**CITY PLAN COMMISSION**

**FILE NUMBER:** PLAT-26-000146

**REQUEST:** An application to create one 5.5568-acre lot from a tract of land in City Block 7749 on property located on North Central Expressway, west of Willowdell Drive.

**PRELIMINARY PLAT**  
**HAMILTON PARK CENTRAL**  
**LOT 1, BLOCK A7749**  
 AND BEING 5.868 ACRES OUT OF THE  
 MARIA JOSETTA SANCHEZ SURVEY  
 CITY OF DALLAS COUNTY, TEXAS  
 WASTEWATER NO. \_\_\_\_\_  
 PAVING AND DRAINAGE NO. \_\_\_\_\_

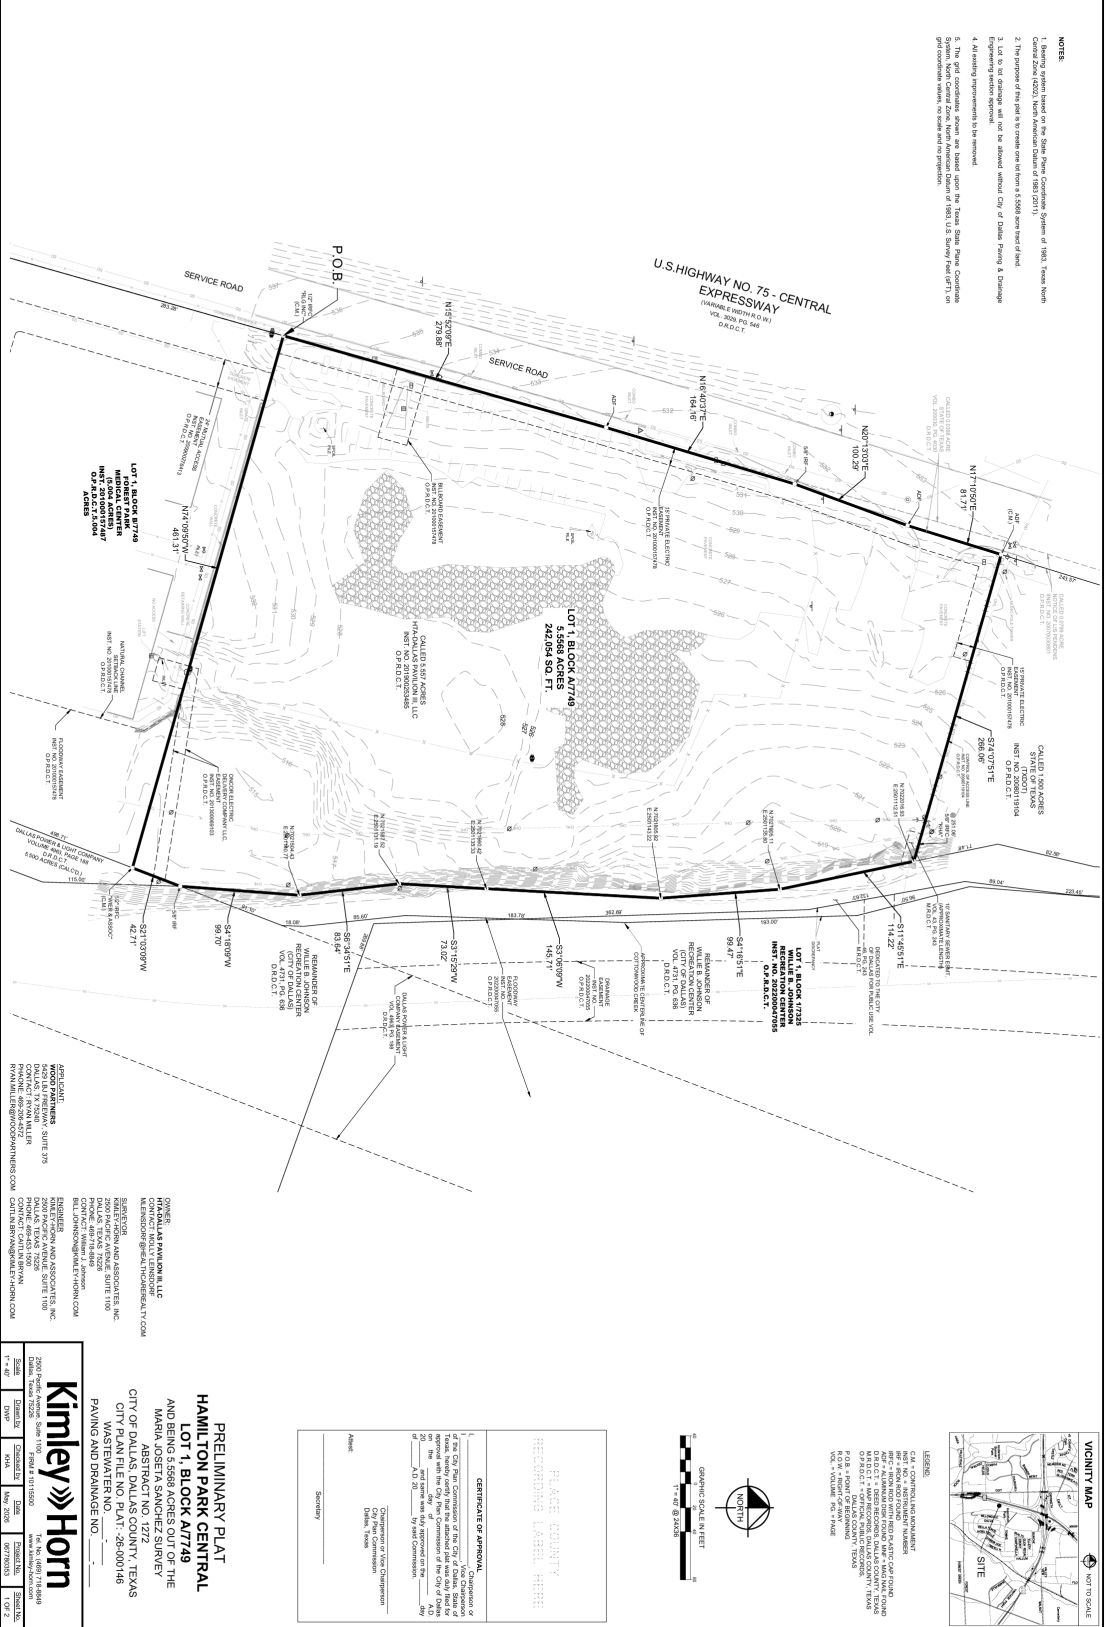
16. On the final plat, determine the 100-year water surface elevation across this addition.
17. On the final plat, dedicate floodway easement, floodway management area or floodway easement (within common area), with the appropriate easement statement included on the face of the Plat. 51A 8.611(d); DWU Floodplain Management; Drainage Design Manual Addendum V

19. On the final plat, specify minimum fill and minimum finished floor elevations. *Section 51A-8.611(d), Trinity Watershed Management.*
20. On the final plat, show the natural channel set back from the crest of the natural channel. *Section 51A-8.611(d), Trinity Watershed Management.*

23. Prior to final plat, submit a completed final plat checklist and all supporting documents.
24. Show/List prior plat on map, in legal, and/or title block.
25. Clarify Volume 46, Page 243, Map Records, Dallas County, Texas.

29. On the final plat, change “U.S. Highway No. 75-Central Expressway” to “Central Expressway/ U.S. Highway No. 75.”
30. On the final plat, identify the property as Lot 2 in City Block B/7749.
